3 Presentation of officer reports

3.1 1 Creswick Street, Hawthorn (Construction of an additional dwelling on a lot) - PP21/0139

PLANNING ASSESSMENT Urban Planning Delegated Committee

Application Number	PP21/0139
Date Application Received	23/02/2021
60 Day Statutory Time Frame	12 April 2024
Planning Officer	Timothy Luckin

Figure 8 - Proposed landscaping

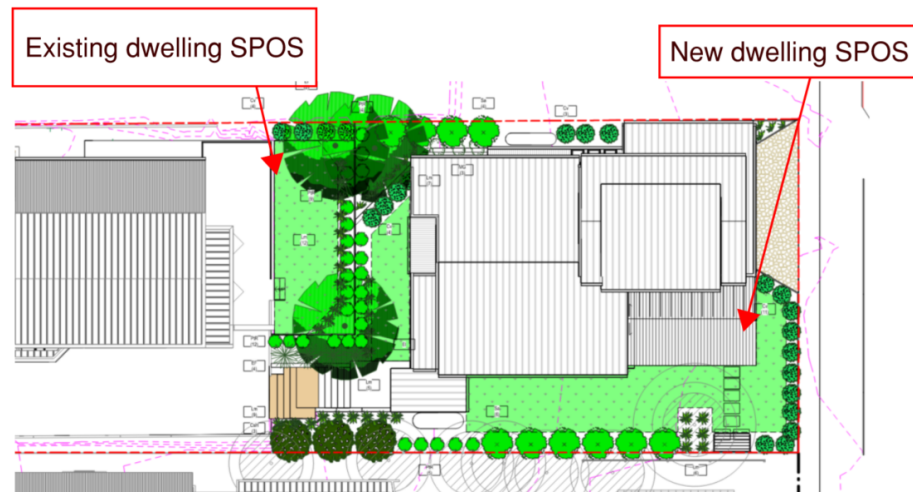
Both the new and existing dwelling have SPOS areas which have a minimum dimension exceeding 3m. A screenshot of the landscape plan is shown in Figure 8 below and

demonstrates there will be large areas provided for new planting including trees. Conditions will require a new small tree to be planted in each secluded private open space.

- b. One (1) small tree (minimum 2 metres tall when planted and must achieve a minimum mature height of 7 metres and canopy spread of 5 metres) in the rear secluded private open space of the front dwelling;

- c. One (1) small tree (minimum 2 metres tall when planted and must achieve a minimum mature height of 7 metres and canopy spread of 5 metres) in the secluded private open space of the new rear dwelling;

- d. Each small tree must be provided a minimum of 12 sqm of deep soil, with the available soil area clearly shown on the landscape plan;
 - e. All trees must comply with Australian Standard AS2303:2015 - Tree Stock for Landscape Use;

Tree 10 - approx location and TPZ/SRZ

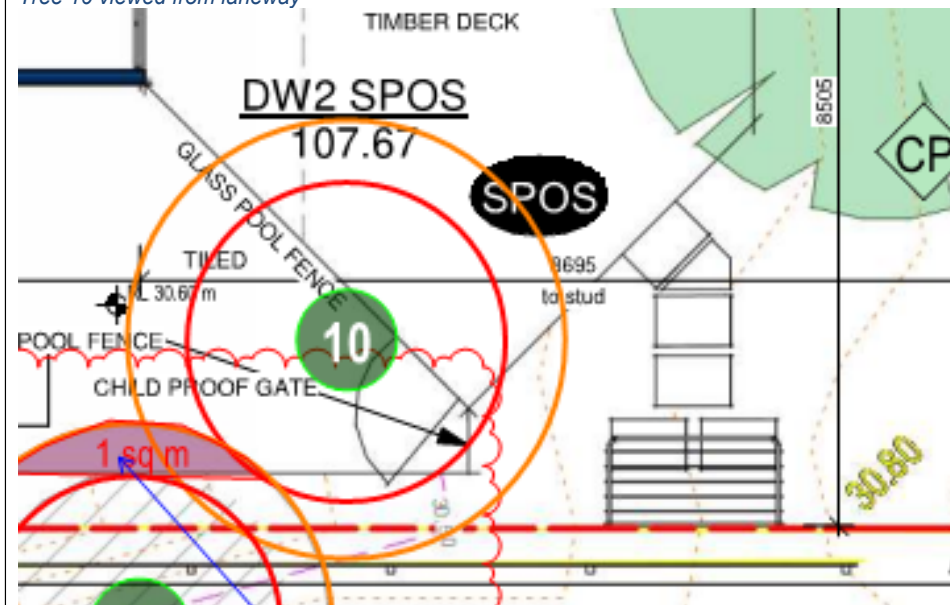
Note: following submission of the S57A plans, this requirement has been satisfied. The only change needed is to move the clothesline out of the TPZ of Tree 10.

This tree has been identified in the arborist report as being of low retention value due to its health, structure and issues with wood borers. The tree is of relatively low amenity and retention value with borer damage observed within the main trunk and branch attachment. The removal of this tree does not require a local law permit. The tree could be retained with the deletion of parts of the deck and reconfiguration of the pool fence, but given its condition, size and potential impacts to property in the future, its removal with more suitably located replacement planting is considered a good outcome.

- g. The front dwelling's storage area to be shown on the floor plans in accordance with Standard B30 (Storage).
- h. Proposed clothesline and associated pavement to be located outside of Tree 10's Tree Protection Zone.

- a) Proposed clothesline and associated pavement to be located outside of Tree 10's Tree Protection Zone.
- b) The Tree Protection Zone and Structural Root Zone of Tree Nos. 10, 12, 13, 14, 15, 17 and 18 (as identified in the Arborist Report submitted with the application prepared by Joe Kellett Arboriculture (dated 28/04/2021) drawn on all site and floor plans;
- c) Notation on all site and floor plans that Tree Nos. 10, 12, 13, 14, 15, 17 and 18 are to be retained and protected in accordance with the endorsed Tree Management Plan required by this Permit;
- d) Any modifications to the location or layout of buildings and/or works recommended in the endorsed Tree Management Plan required by this Permit;
